PLANNING REVIEW CHECKLIST

Subject Property: 835 Commercial Street SE

Reference Nos.: 22-117603-PLN (Class 3 Site Plan Review)

SITE PLAN REVIEW
HUNSAKER DENTAL CLINIC
835-877 COMMERCIAL ST SE

SPR-5

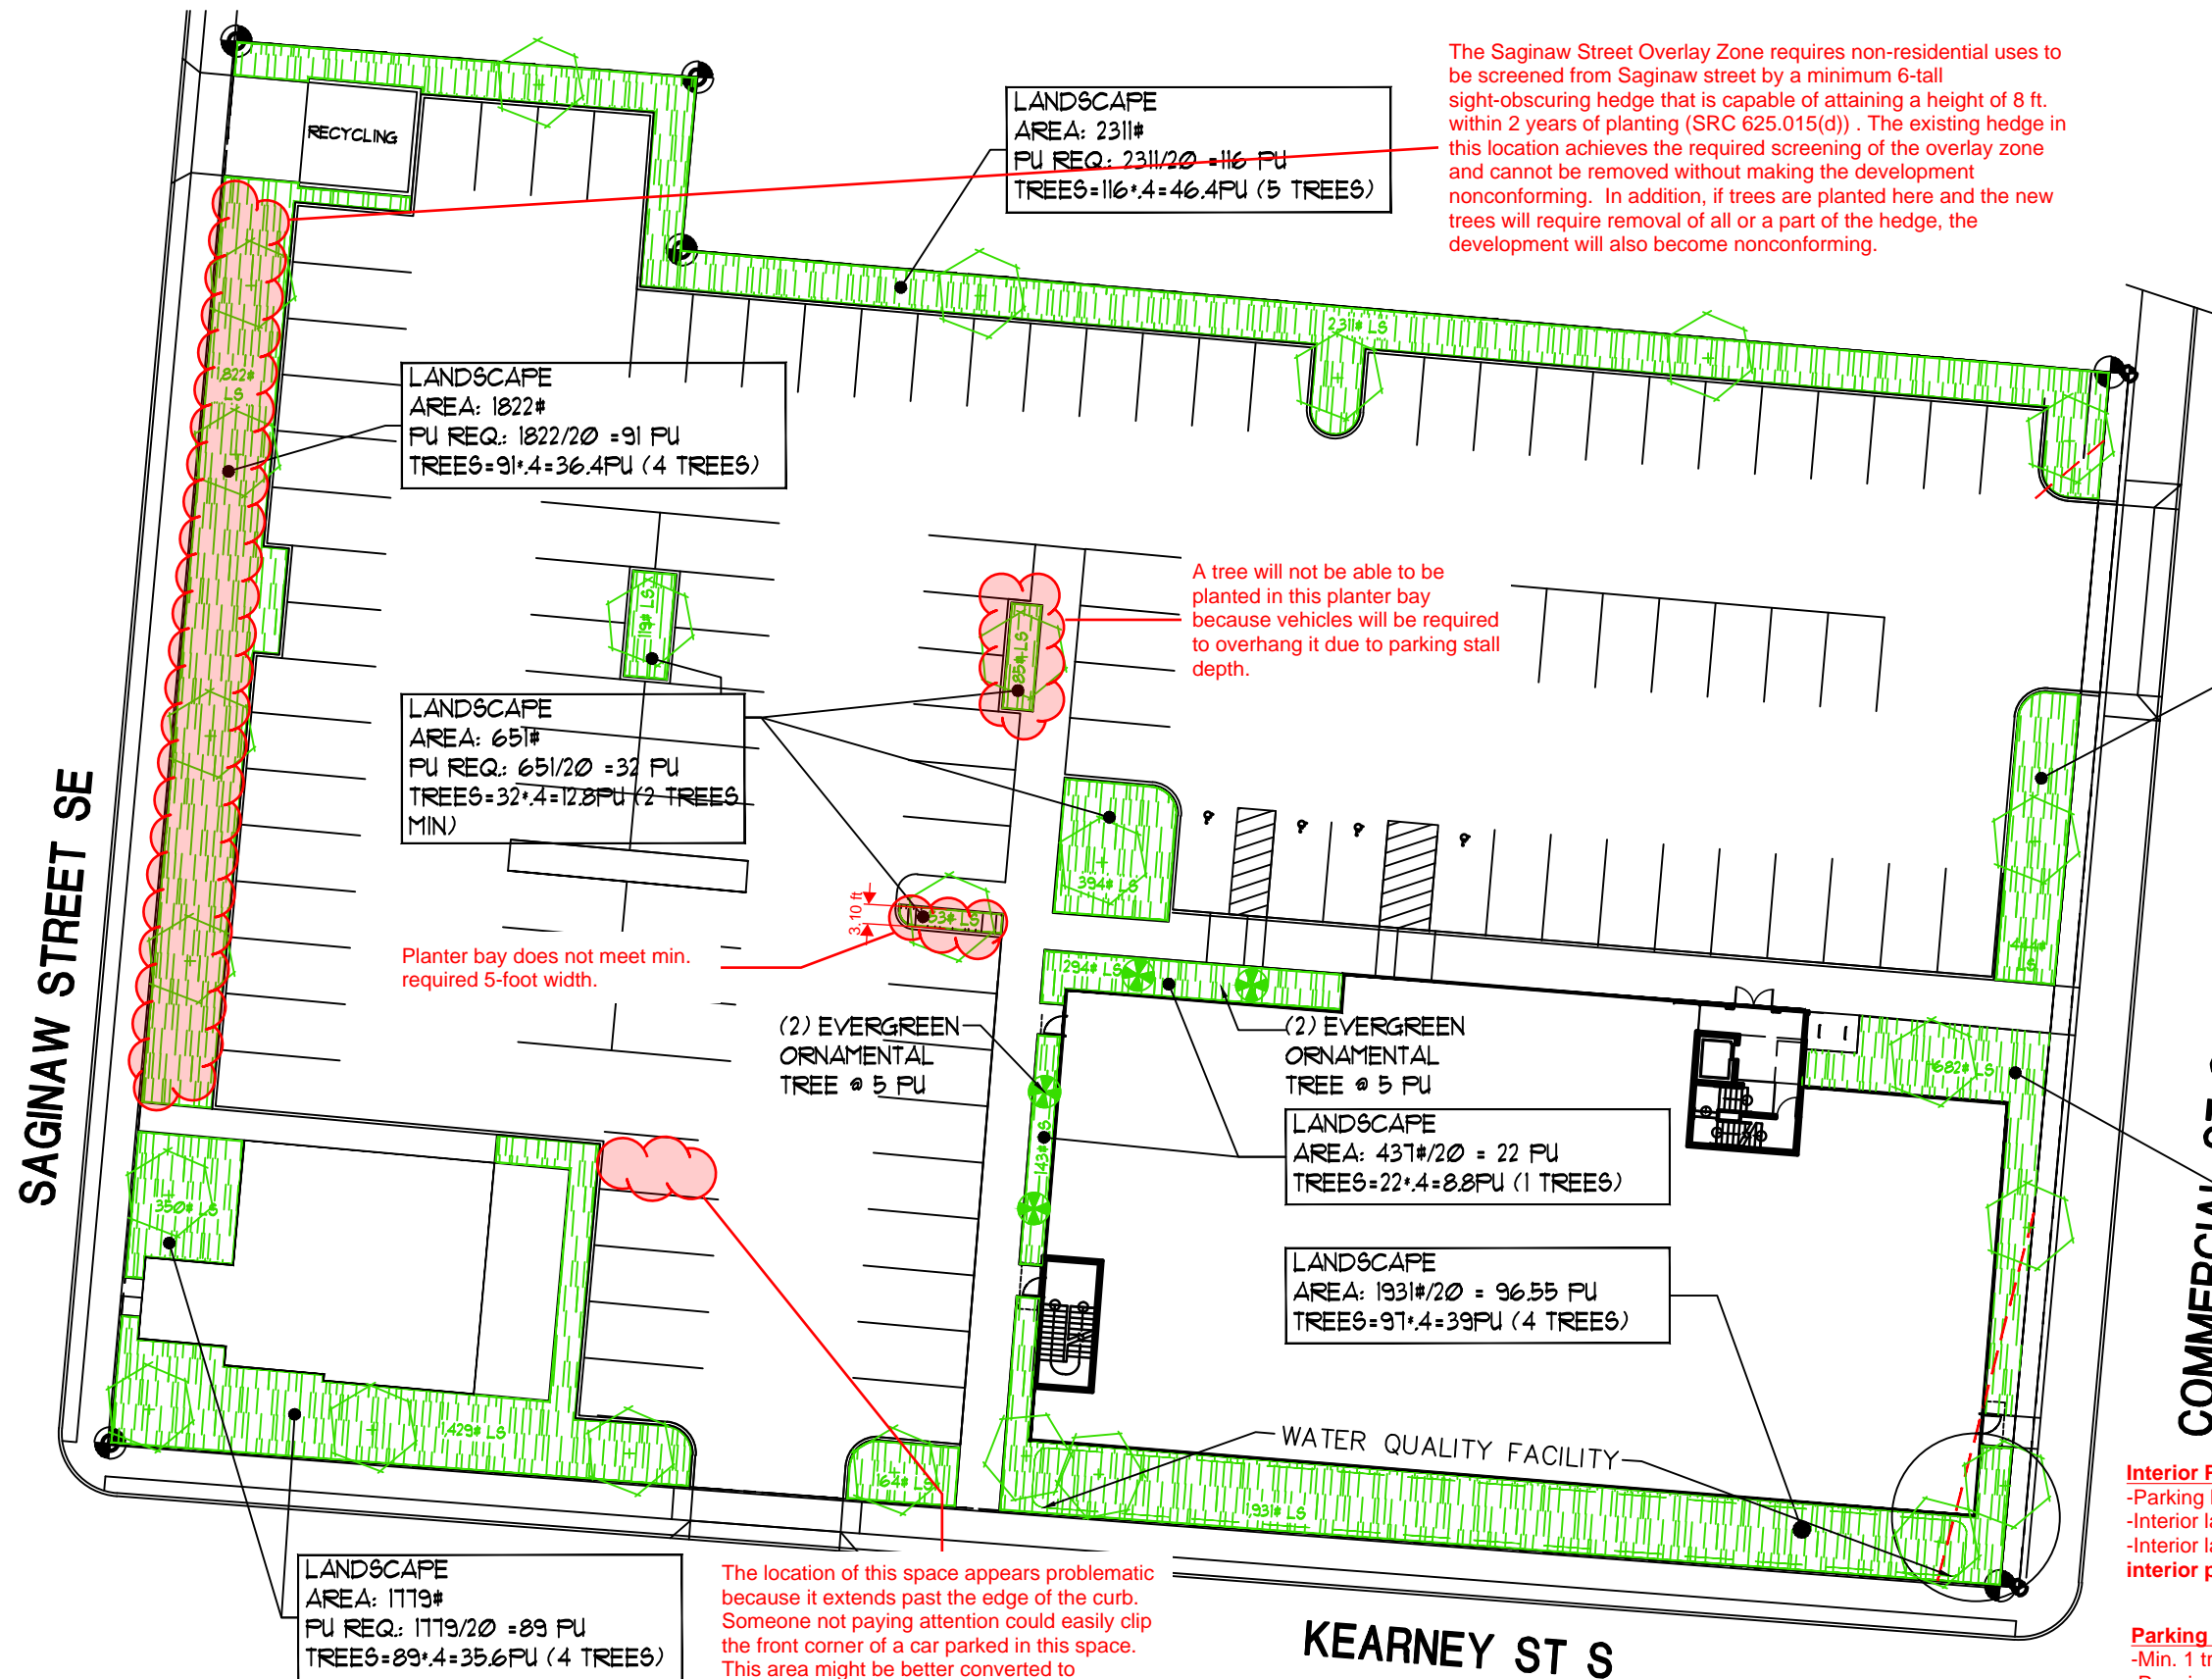
The location of this space appears problematic because it extends past the edge of the curb. Someone not paying attention could easily clip the front corner of a car parked in this space. This area might be better converted to landscaping in order to meet interior parking lot landscaping requirements.

Interior Parking Lot Landscaping

- Parking lot area: 34,714 ft.²
- Interior landscaping required: 0.05 x 34,714 ft.² = Min. 1,735.7 ft.²
- Interior landscaping provided: **806.25 ft.² (Additional 929.45 ft.² of interior parking lot landscaping required)**

Parking Lot Trees

- Min. 1 tree per 12 parking spaces required.
- Required trees: $109 / 12 = 9.08$ or 9 trees min.
- Trees provided: **5 trees (Additional 4 interior parking lot trees required)**
